TECHNICAL MEMORANDUM

Reference No. 20446521-007-TM-Rev0-6000

LMI RESPONSE TO CIRNAC'S COMMENTS ON THE DOME DESIGN ISSUED FOR CONSTRUCTION DRAWINGS FOR WATER LICENCE NO. 2AM-LUP2032 – LUPIN MINE PROJECT

TITLE
PROPOSED WASTE ROCK DOME

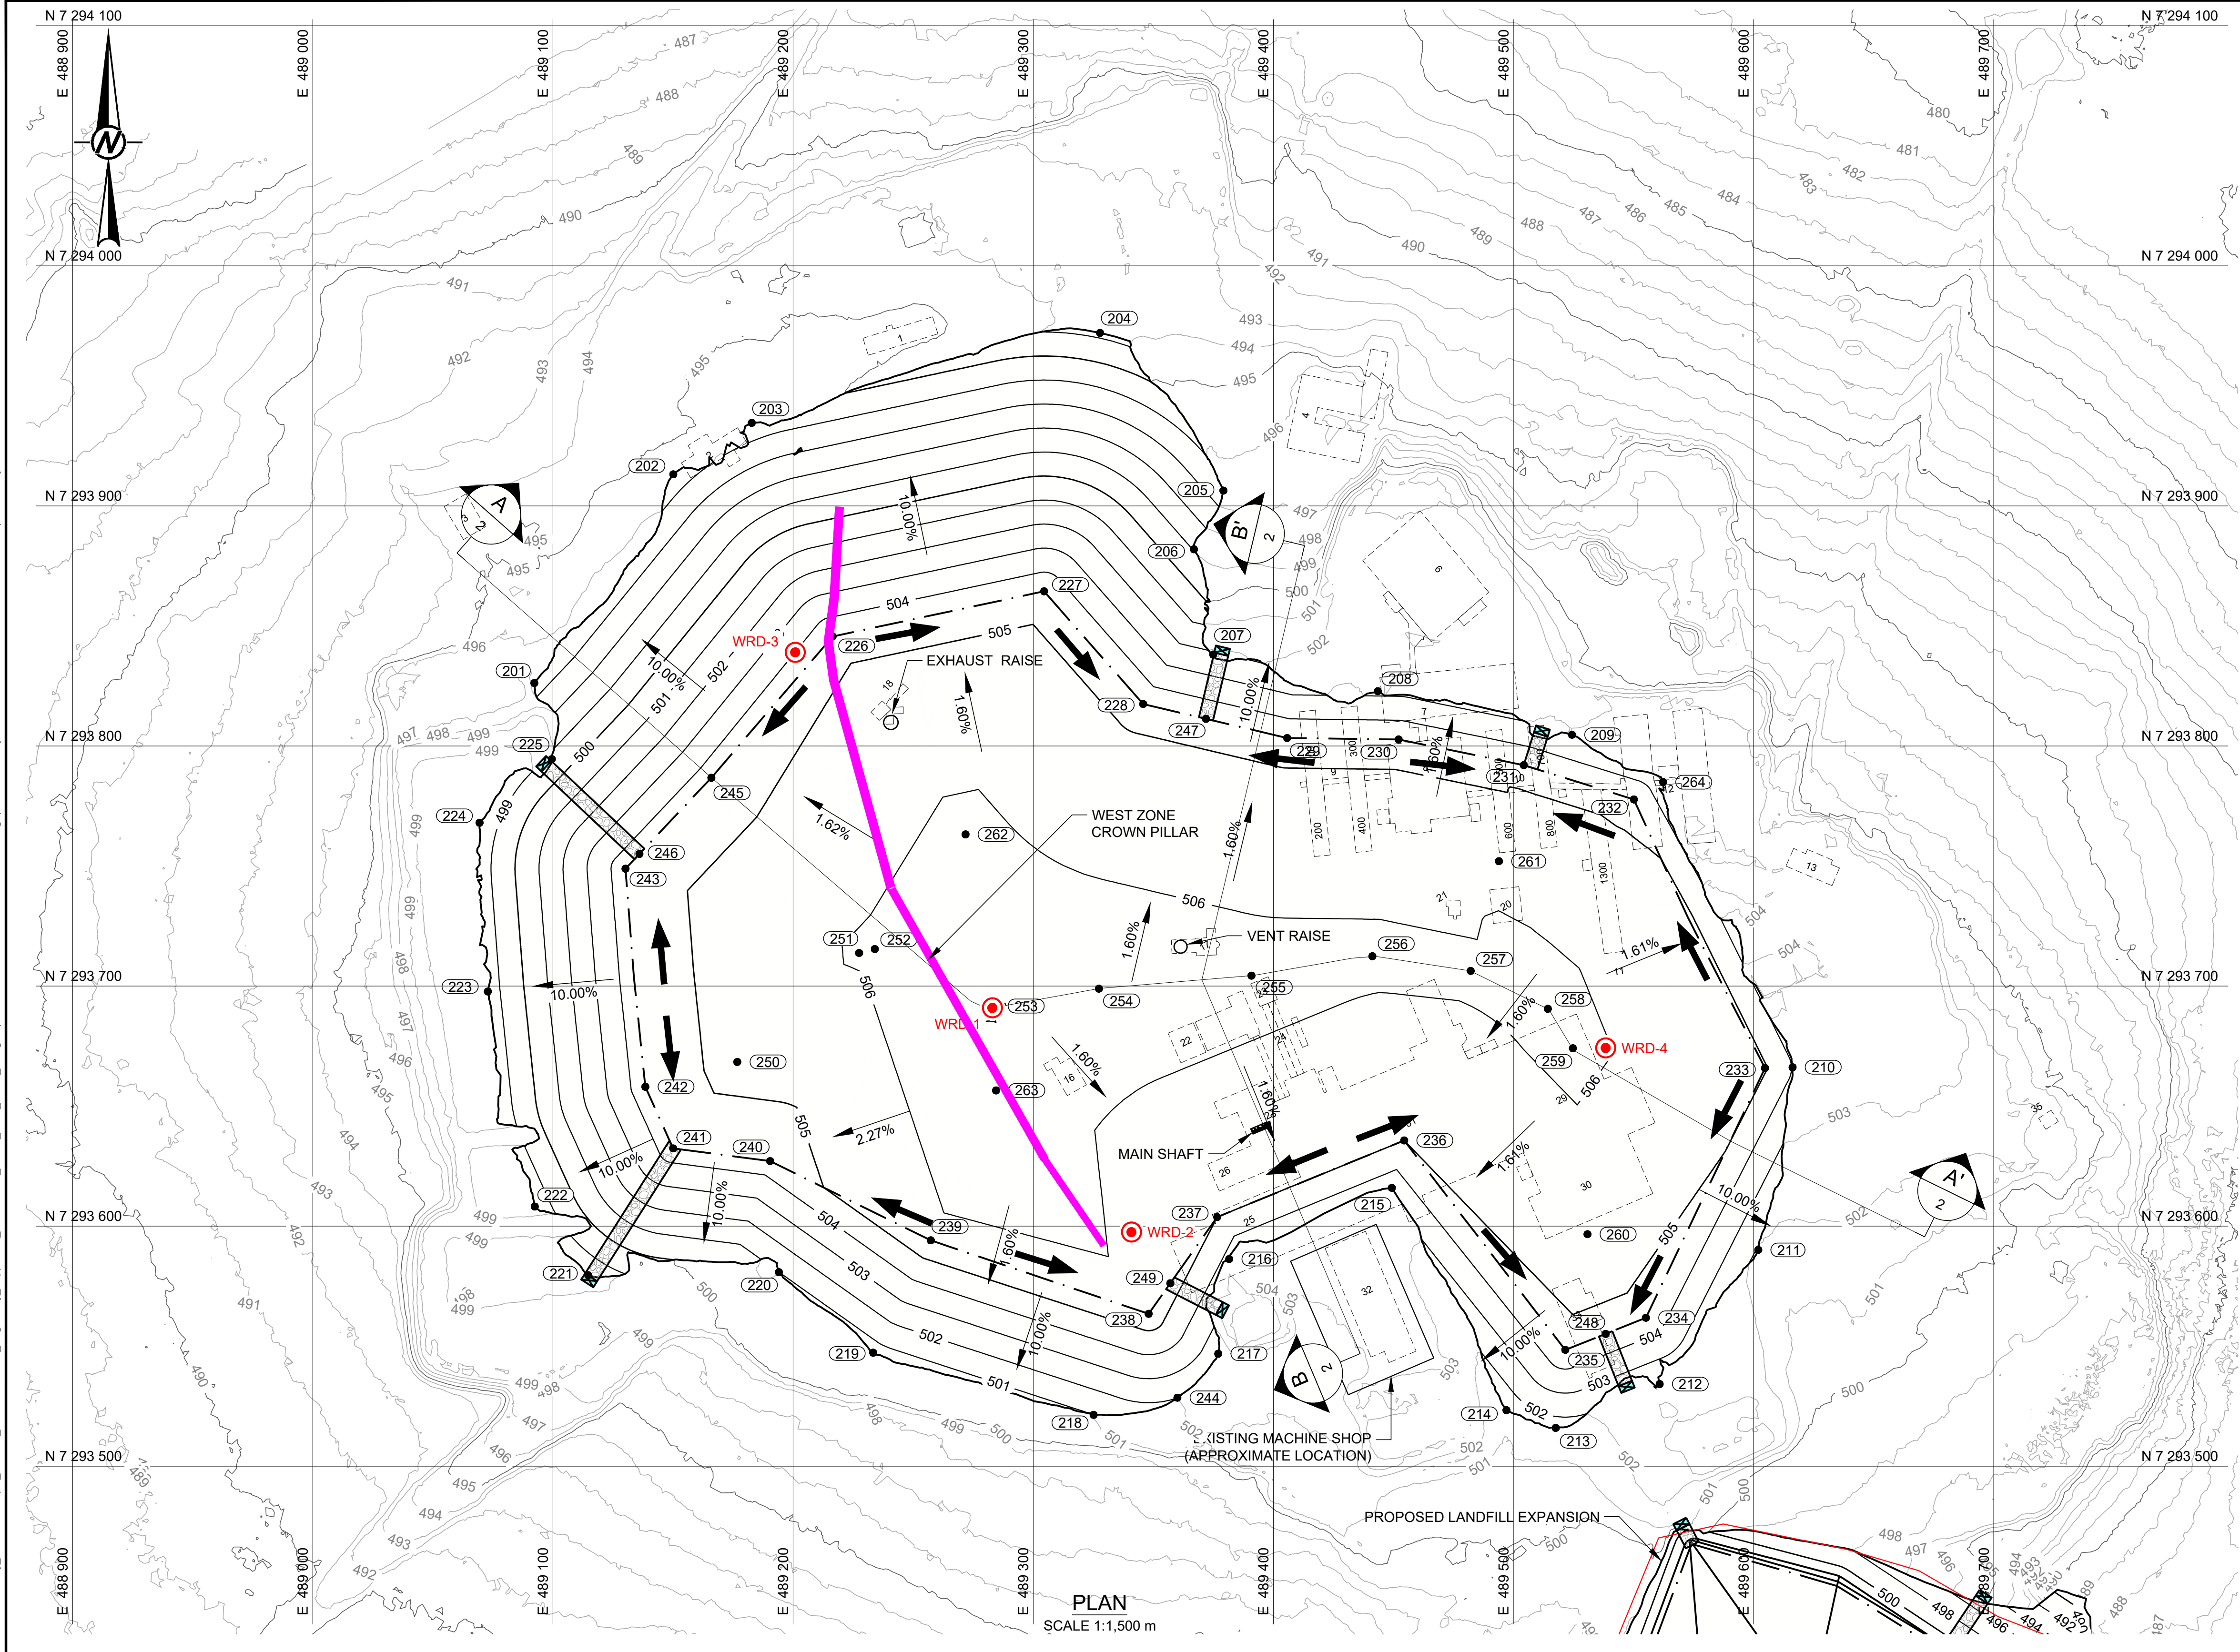
#	Original CIRNAC Comment	LMI Previous Response	Current Comment / Status	LMI Response
a	Lack of detailed grading information on the top of "dome" – LMI in response, states that the grading details are provided in issued for construction drawing 19136158-0002-CM-0001_Rev 1.	"As indicated in Note 7, the final elevation of the top surface will be varied to suit the actual volume of waste rock that is imported from elsewhere on the mill site; however, the design slopes of the surface will not be changed."	CIRNAC concerns were addressed.	Resolved.
b	Lack of design information on storm / freshet flows – LMI in response stated that the chutes were designed to accommodate discharge flows in excess of 1 m ³ /s. CIRNAC requests the design calculations for the design flow along with confirmation that the esker material on the dome cover can withstand the movement of this amount of water as it migrates to the surface water management chutes. Also, the design should identify the preferred surface water flow patterns that will be established on the top of the dome so as to confirm if reinforced swales (i.e., boulder or riprap lined channels) are required to move water to the respective chutes.		CIRNAC concerns have not been addressed to date.	Refer to 20446152-005-TM, "Supplemental Information on the Design of the Dome and the Landfill", which is attached to the minutes of the meeting of July 22. The memo demonstrates that the design flow of 1 m ³ /sec. considerably exceeds the flow corresponding to a 100 year return storm of 5 minutes duration (0.39 m ³ /sec.). At the design flow of 1.0 m ³ /sec, the calculated flow depths and velocities are 0.129 m and 2.56 m/sec in the chute section and 0.312 m and 0.99 m/sec. exiting the stilling basin. Design charts indicate that 10 kg class rip rap is adequate for these velocities. Arrows have been added to Rev 2 of Dwg. 19136158-002-CM-001 (attached).

d	Lack of runoff channels from discharge chutes – LMI's response indicates that due to setting on top of the hill, runoff from chutes will naturally drain away from the toe of the waste rock cover slopes.	Note 11 has been added to Drawing (Dwg) 19136158-0002-CM-0001_Rev 1 directing the Contractor to "construct berms or ditches as necessary to direct flow from drainage chutes away from the toe of the dome fill".	CIRNAC concerns were addressed.	Resolved

f	Lack of specific notes addressing construction constraints that need to be addressed before cover placement	LMI added two notes to drawing 19136158-0002-CM-0001_Rev 1: o Note 1: “The subgrade under the dome is to be prepared in accordance with the water licence and final closure and reclamation plan (FCRP) before imported waste rock or cover materials are placed.” o Note 2: “The following materials shall be removed from the existing subgrade before imported waste rock is placed: Demolition waste, petroleum hydrocarbon contaminated soils, Arsenic “Hot Spots”, Soil or Rock materials impacted with Cyanide or Lead Nitrate and any hazardous waste.”	Note 1 is a broad and undefined statement with no guidance on what is intended in the dome design package related to this note. Without additional guidance on what is needed/expected, LMI, the contractor, CIRNAC and others may all have different interpretations for what is required. LMI should provide clear guidance to the contractor to ensure what needs to be done is carried out and can be verified as having been done either before waste rock relocation or cover.	Note 1 has been modified on Dwg 19136158-0002-CM-0001_Rev 2 (attached) to add the statement, “Engineer’s approval of cleanup is required before waste rock or cover materials are placed.” As described in the minutes of the meeting of July 22, cleanup activities are under full time inspection and testing by a Golder field crew who are monitoring the contaminated soil excavations and are completing filed screening using either a RKI Eagle (PHC soil) or XRF (metal soils). Upon reaching anticipated final extents, confirmatory soil samples are sent offsite for lab analysis. The QA/QC program for soils is included in

g	Failure to show where materials to be removed prior to cover placement are located	LMI indicated that the locations of contaminated materials are shown on Dwg 19136158-0005-CM-0001_Rev D.	CIRNAC concerns were addressed.	Resolved
h	Failure to show locations of shaft, crown pillar area that will be buried under the dome	LMI in response states that locations of shafts, crown pillar area buried under the dome have been added to Dwg 19136158-0002-CM- 0001_Rev 1.	CIRNAC concerns were addressed.	Resolved

#	Issue	Concern	Recommendation	LMI Response
a	Concrete Foundations	Various mill facility foundations and slabs will be left in place, buried in waste rock and covered. The Dwg does not provide any information on the locations slabs and foundations that will be buried within the dome.	CIRNAC recommends that LMI add the outlines of all slabs and foundations that will be buried within the dome to the site Dwg and where applicable to the sections.	Outlines of the building foundation slabs have been added to Dwg 19136158-0002-CM- 0001_Rev 2 (attached).
b	Length of Embankment	The embankment between E 489 100 to E 489 375 and N 7 293 800 to N 7 293 975 is greater than 100m in length with no identified breaks or energy dissipating structures to slow down any sheet flow during high intensity rainfall events. The concern is that the esker material on site has a significant fine-grained component and as such may be susceptible to the migration of fines over time.	CIRNAC recommends that LMI review the design to confirm that esker material will not migrate during high intensity rainfall events and provide written confirmation that fine grained materials will be washed out of the embankment cover esker material.	The sideslopes are not expected to erode from the sheet runoff that will result from snow melting or rainfall on the sideslopes themselves. This is based on observations of the performance of slopes on dams constructed with well graded sand and gravel. One such slope stood up well over the course of about 15 years of annual inspections, notwithstanding the fact that it was much steeper at 2:1 (H:V).

c	West Zone Crown Pillar Cover and Note 4	Note 4 states that the crown pillar and shafts are to be filled before waste rock is placed on top. However, in section 4.3.2.4 of the FCRP, page 4-15, it is stated that capping material will be required over the newly opened and filled West Zone that will consist of a 1.5 m thick mound over the backfill material with 3:1 sideslopes and that this capping material will be covered with 1m esker materials graded at 2% slopes to shed water and conform to the surrounding land form. There is nothing on the Drawings 1 or 2 or the notes that identifies the need for this additional cap over the crown pillar. It is our understanding that the cap over the crown pillar was planned to allow for consolidation of the underlying fill materials without creation of a sinkhole in the dome cap and cover.	CIRNAC recommends that LMI revise the Dwg and notes to ensure that the additional capping materials are placed as appropriate prior to placement of the cover.	The capping over the backfilled West Zone crown pillar will be integrated into the overall dome landform. It is expected that most of the settlement of the backfill in the crown pillar will occur before the dome is brought to its final grade. The following sentence has been added to Note 4 of Dwg 19136158-0002-CM- 0001_Rev 2 (attached), "Place an additional ridge of waste rock to allow for settlement if so directed by the Engineer."

#	Issue	Concern	Recommendation	LMI Response
d	Stilling Basins	<p>The stilling basins should be set at grade surface and not cut into the ground beneath the toe of the embankment as this could lead to ponding and potential freezing of water in the basin thus reducing the effectiveness of the basins during the freshet or other periods of high surface water runoff.</p> <p>Furthermore, additional detail is required to confirm positive drainage of water from the stilling basins away from the toe of the dome embankment.</p>	CIRNAC recommends that LMI amend the stilling basing design to provide additional detail in order to confirm a positive drainage of water from the stilling basins away from the toe of the dome embankment.	<p>The recessing of the stilling basins into the original ground is based on similar designs used successfully at other northern sites. The reverse slope at the end of the stilling basin is more effective at containing the hydraulic jump within the stilling basin as opposed to a stilling basin built on top of original ground.</p> <p>Note 11 has been modified on Dwg 19136158-0002-CM-0001_Rev 2 (attached) to read, "Construct ditches or berms as necessary to direct flow from drainage chutes and general runoff away from the dome fill."</p>

e	Drainage at the Toe of the Embankment	<p>It is unclear how the contractor is to understand final grading at the toe of the dome embankment and how to ensure surface water is directed away from the embankment toe, particularly in areas where initial grading work is required to remove undesirable materials.</p> <p>Furthermore, consideration should be given to sizing the material at the toe of the dome embankment so as to ensure that surface water flow at the toe does not result in riling or loss of fines from the esker material being placed as part of the waste rock cover.</p>	<p>CIRNAC recommends that LMI provide additional drawing notes to provide guidance to the contractor as well as to the program stakeholders on how surface water will be directed away from the toe of the dome embankment.</p> <p>Consideration should be given to placing coarser material or armouring at the toe of the dome embankment.</p>	<p>The original ground surface adjacent to the toe of the dome is currently obscured by existing waste rock. As discussed above, a Golder geotechnical engineer will be on site later in the summer to verify that adequate drainage is achieved by "field fitting" to the original ground surface adjacent to the toe of the dome.</p> <p>Note 11 has been modified on Dwg 19136158-0002-CM-0001_Rev 2 (attached) to read, "Construct ditches or berms as necessary to direct flow from drainage chutes and general runoff away from the dome fill."</p>
